Subject: Response to Department of Toxic Substances Control Comments Regarding the "Field Sampling Work Plan to conduct additional groundwater investigations within and in the vicinity of the BAPB at the University of California Richmond Field Station, Richmond, California"

Response to DTSC February 22, 2012 Comment Letter

<p>SAFETY FIRST</p> 	CLIENT:	Zeneca, Inc.	<p>UCRFS BAPB Additional Investigation</p> <p>FIGURE 2 (REV 1.0)</p>
	PROJECT:	Campus Bay Richmond, CA	
	PROJECT NUMBER:	0009.002.007

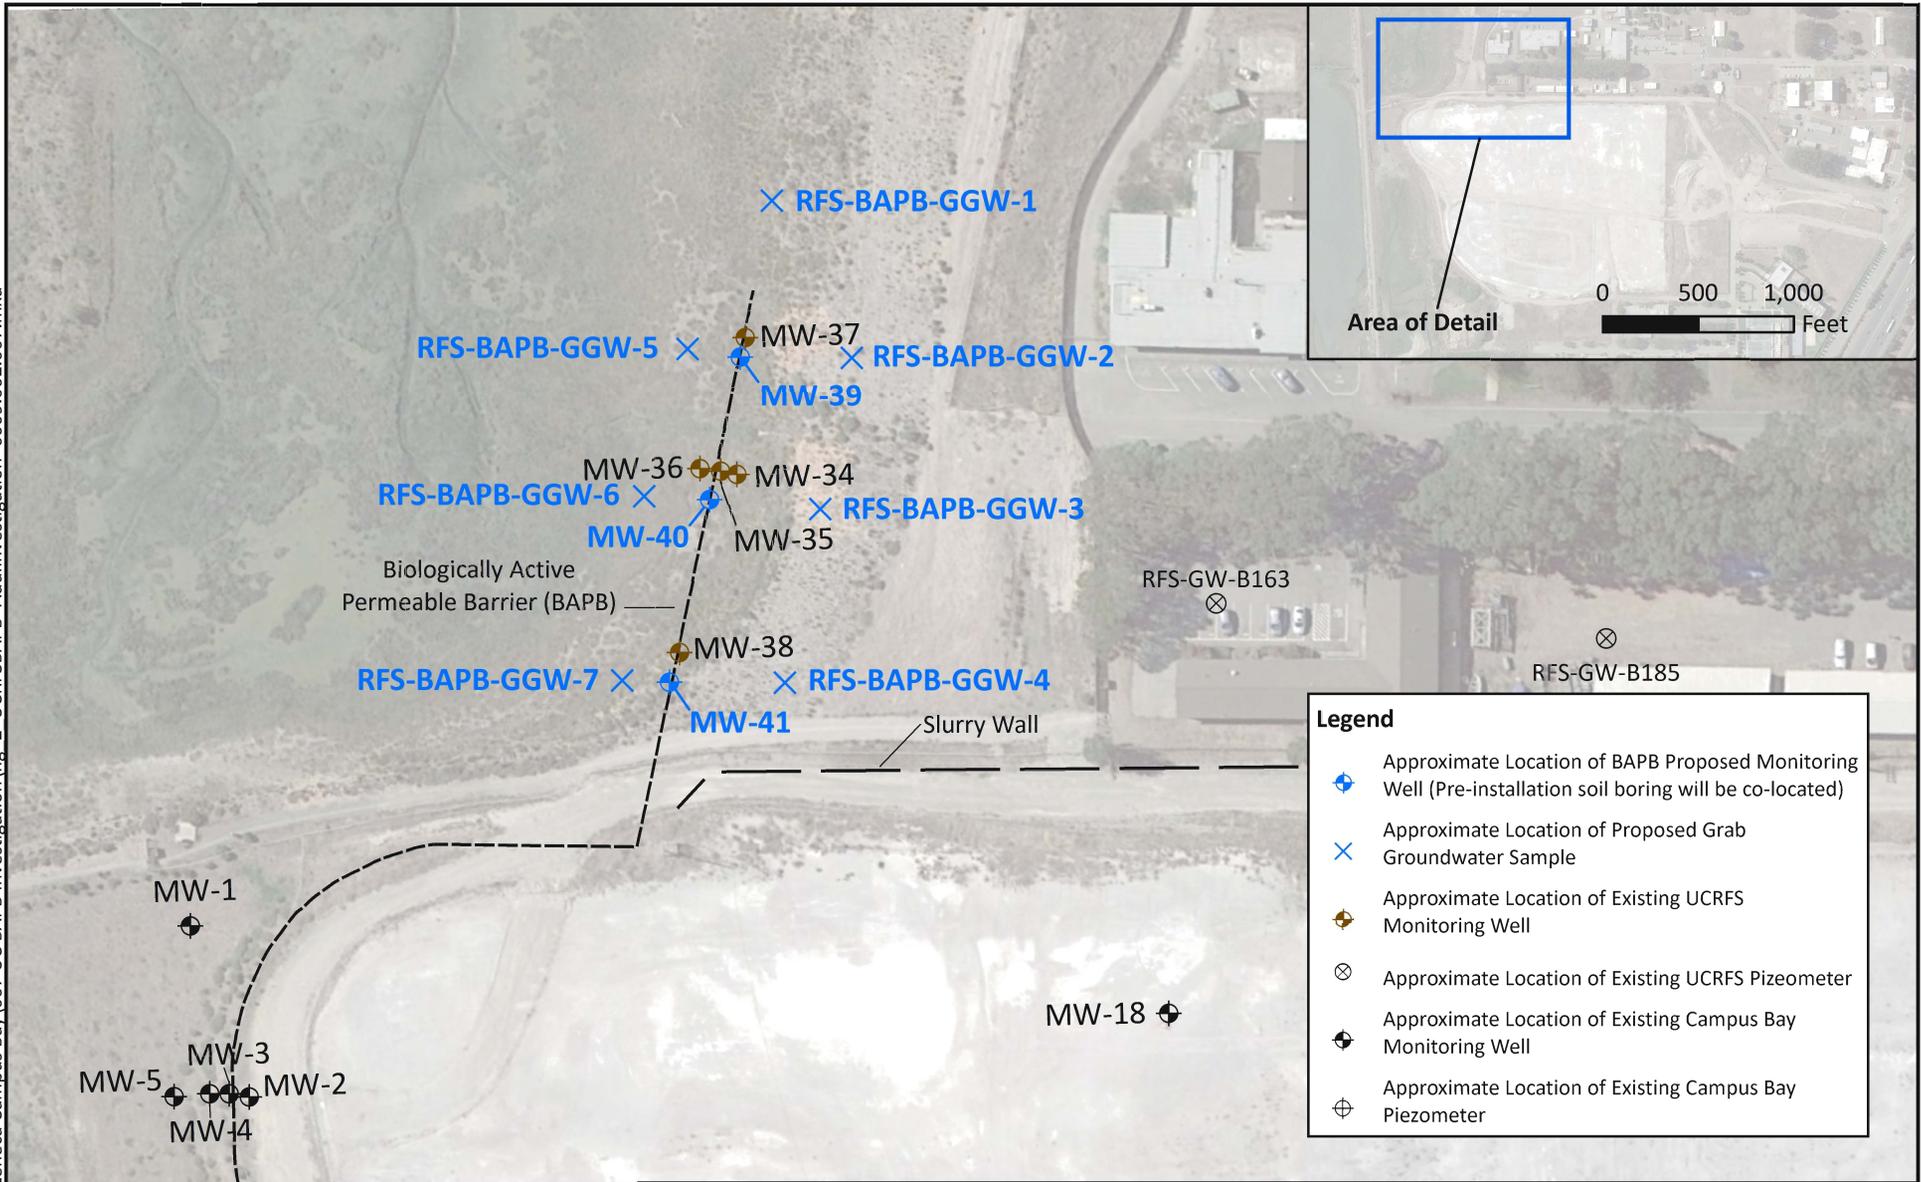
"Provide a table identifying well and grab sample numbers and depths, analytical methods, sample volumes, containers, filtration, preservatives and other handling details."

To address this comment, Terraphase has prepared Table 1, attached to this letter. In addition, Figure 2 of the Work Plan has been updated to include sample identification for the proposed grab groundwater sample soil borings and BAPB monitoring wells.
